METROPOLITAN GOVERNMENT OF NASHVILLE AND DAVIDSON COUNTY

STAFF RECOMMENDATION
1406 5th Avenue North
October 21, 2015

Application: Partial demolition; New construction—addition
District: Germantown Historic Preservation Zoning Overlay
Council District: 19
Map and Parcel Number: 08209008800
Applicant: John Root, Architect
Project Lead: Melissa Baldock, melissa.baldock@nashville.gov

Figure 6. The Metro Map showing the topography of the site

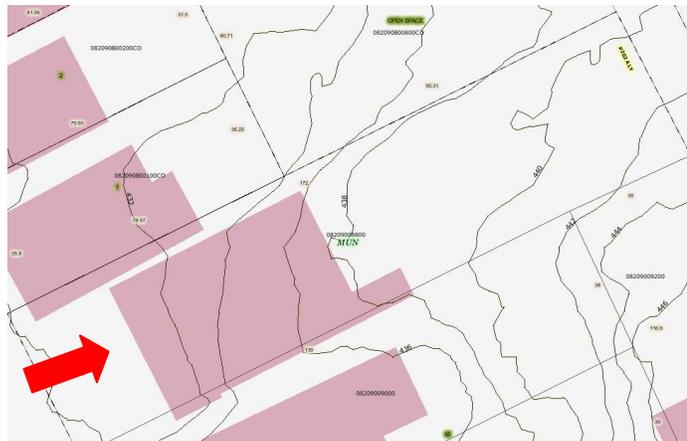
Height and Scale. The site is steeply sloped upwards towards the back of the lot; there is a difference of about ten feet (10') from the front of the lot to the rear (Figure 6). Because of the steep slope of the lot, staff will compare the heights of the historic house and the addition as measured from the finished floor line.

SITE & DEMOLITION PLAN

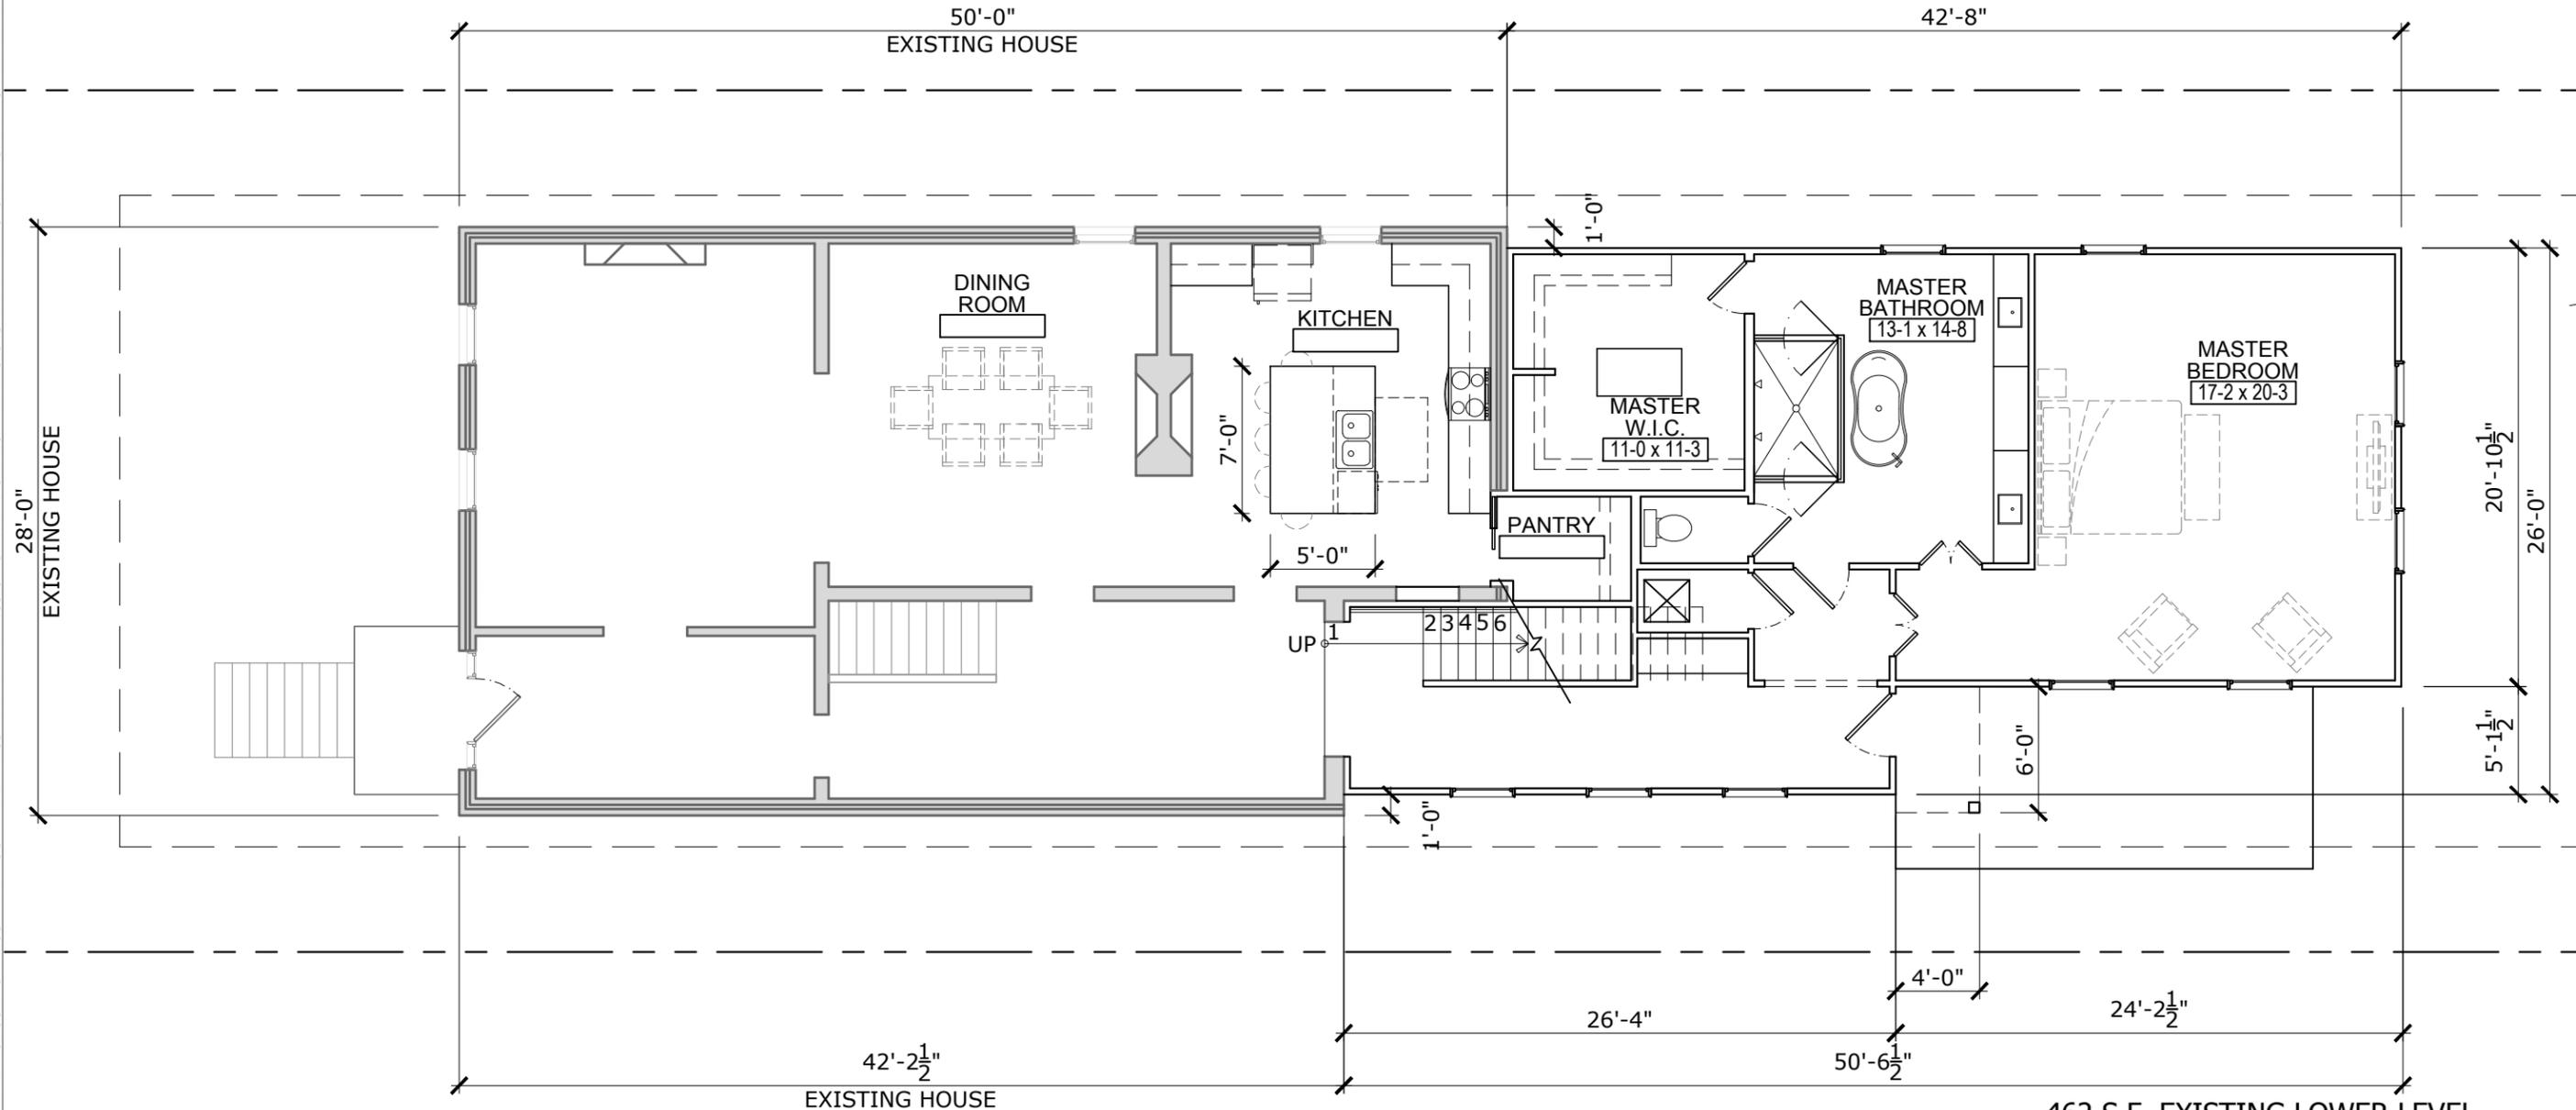
Partial Demolition. The applicant proposes to demolish an existing addition at the rear of the house. This part of the structure does appear on the 1914 Sanborn Map, and is shown as a distinct element from the rest of the house (Figure 2). The existing addition is clad in siding and has a separate roof from the brick house (Figures 3 - 5). It is located over forty-feet (40’) from the front of the house on the right side and about fifty feet (50’) from the front on the left side. It is at most minimally visible from the street. Staff finds that the existing addition does not contribute to the historic character of the historic house at 1406 5th Avenue North and to the Germantown Historic Zoning Overlay as a whole. Staff finds that its demolition meets Section 7.2.2. for appropriate demolition and does not meet Section 7.2.1. for inappropriate demolition.

Setback. The proposed addition meets all base zoning setbacks, and staff finds that it meets Sections 2.2.1. and 4.2. of the design guidelines.

Appurtenances and Site Features. No proposed changes to the appurtenances or site features were indicated on the site plan. All changes to the site features, including fencing, pathways, driveways, etc must be approved by MHZC.

WEST ELEVATION

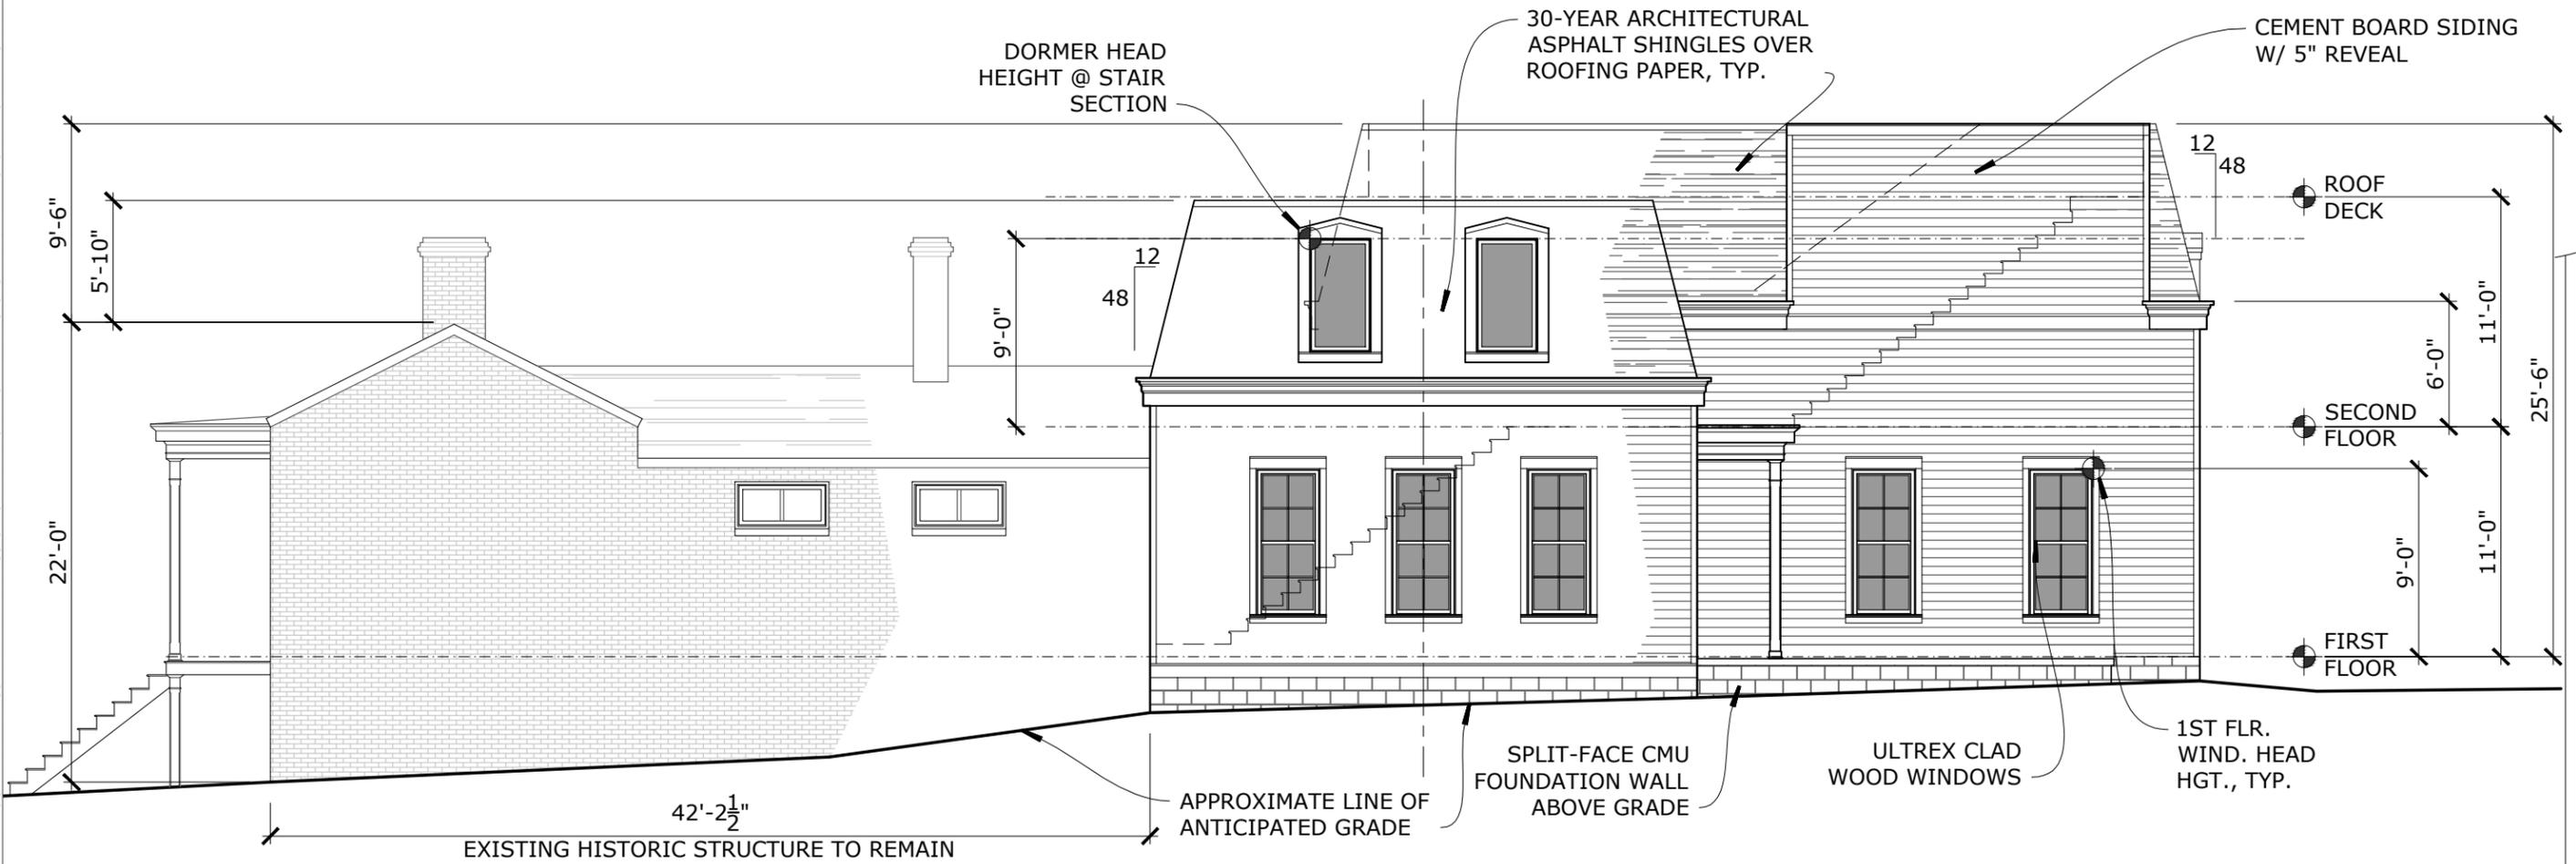
historic house. The historic house has a maximum height of sixteen feet (16') above the finished floor line. The rear cross gable portion of the addition has a height of about fourteen feet (14') above the finished floor line. The eave height of the historic house is about eleven feet (11') for the front, side gabled portion of the house, and nine feet (9') for the rear cross gable portion, as measured from the finished floor line.

The proposed two story addition will be a total of nine feet, six inches (9'6") taller than the historic house, and will be about eleven feet, six inches (11'6") taller than the cross-gabled portion of the house. The eave height of the addition on the left/south elevation is taller than the ridge of the historic house, which it not something the Commission has approved in Germantown or any other historic preservation or conservation overlay in the past.

Roof. This historic house has a side gabled roof with a pitch of approximately 5/12. The proposed roof form is a mansard roof with a 48/12 pitch. Mansard roofs are not common

on historic houses in Germantown, although they have been approved for infill. Nevertheless, staff finds that the proposed mansard roof accentuates the additional height of the addition and is not visually compatible with the historic house and its roof. The proposed roof form contrasts significantly from the historic house. Staff therefore finds that the proposed roof form does not meet Sections 2.7, 4.2.2., 4.2.5. of the design guidelines.

SOUTH ELEVATION

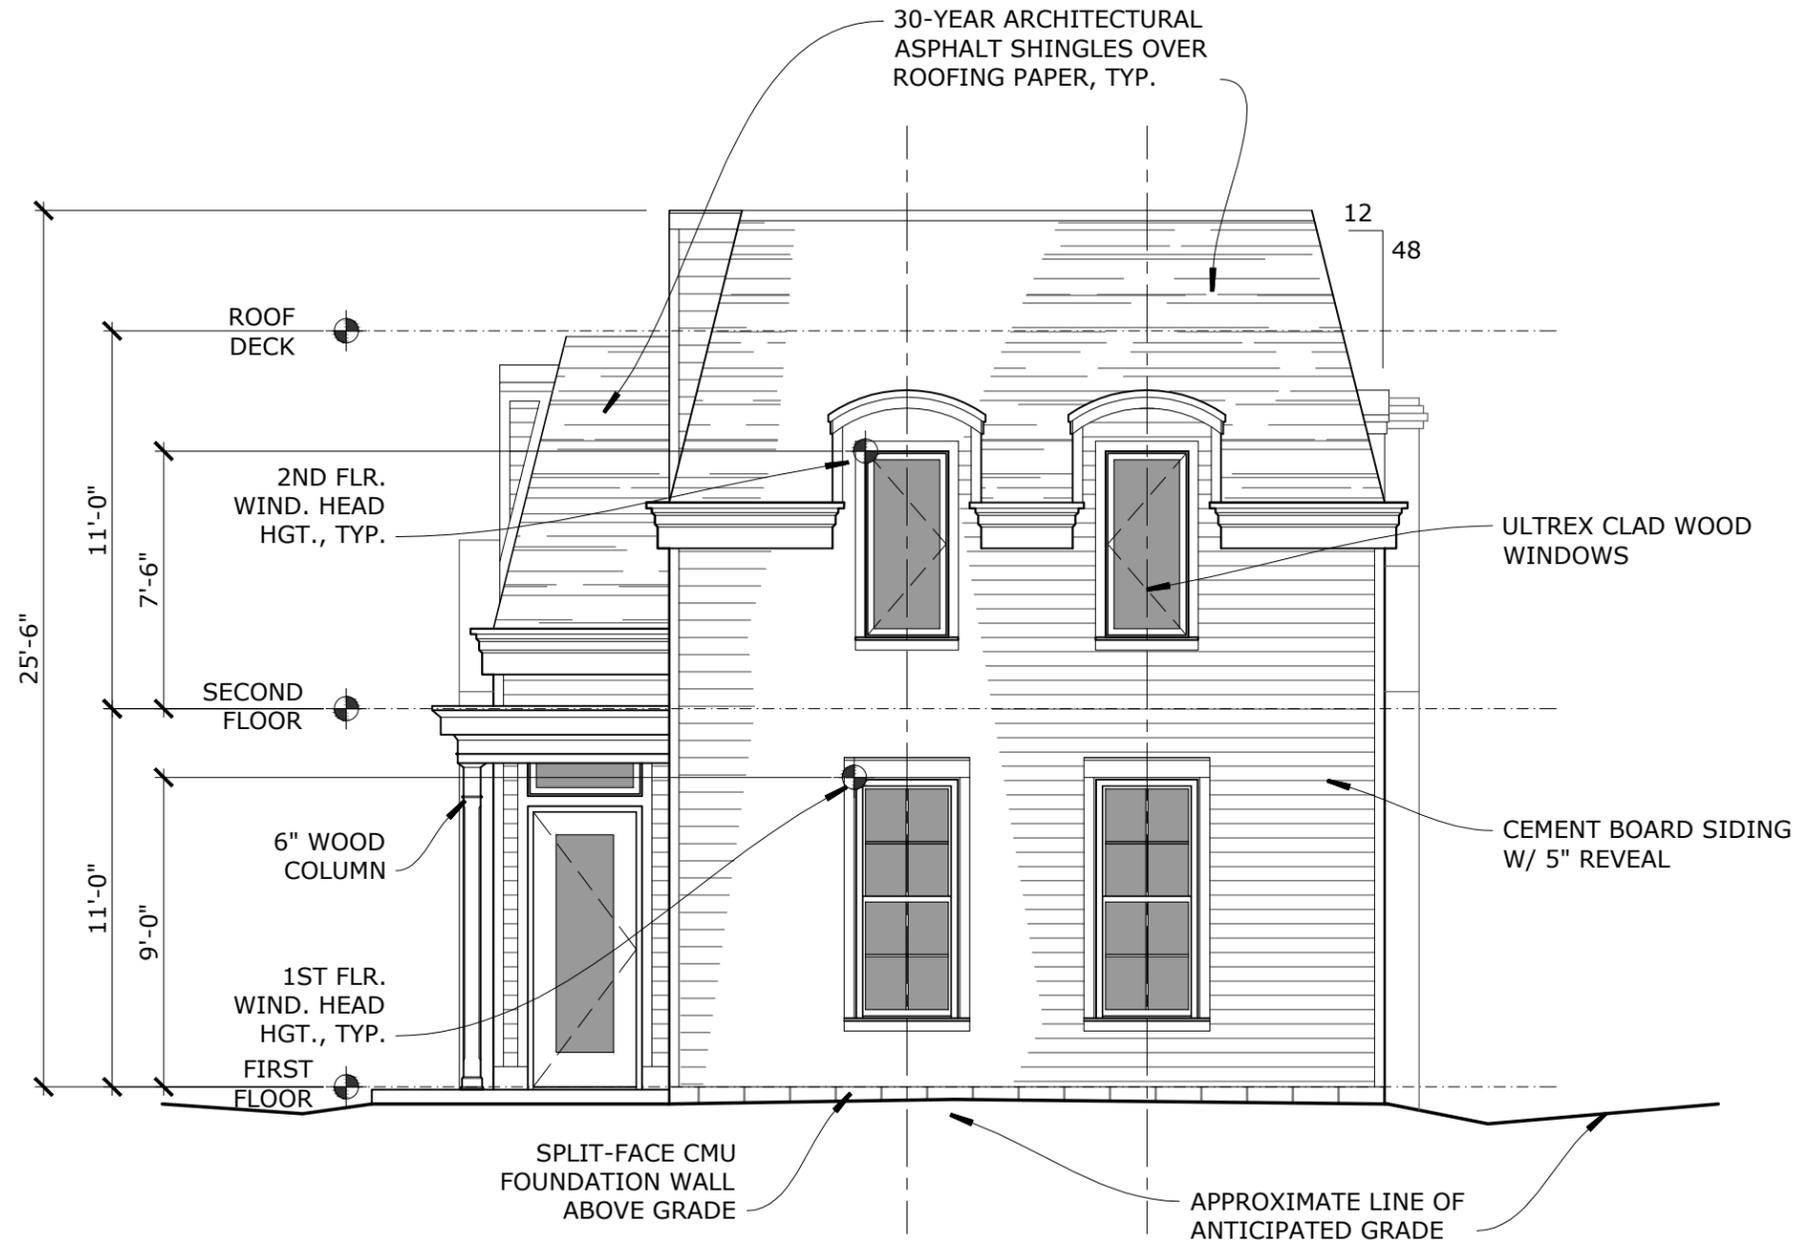
Windows and Doors. The drawings do not indicate any changes to the existing window or door pattern. The addition's windows are generally twice as tall as they are wide, thereby meeting the historic proportion of window openings. There is an expanse of seventeen feet (17') without a window or door opening on the south/left elevation, which staff finds to be appropriate because this portion of the addition is over fifty feet (50') from the front of the house. The addition's second story contains wall dormers in the mansard roof. Wall dormers are not a common historic feature in Germantown, and they accentuate the perceived height of structures. The Commission does not typically

approve wall dormers. Staff finds that the proposed wall dormers do not meet Sections 2.5, 2.6, and 4.0. of the design guidelines.
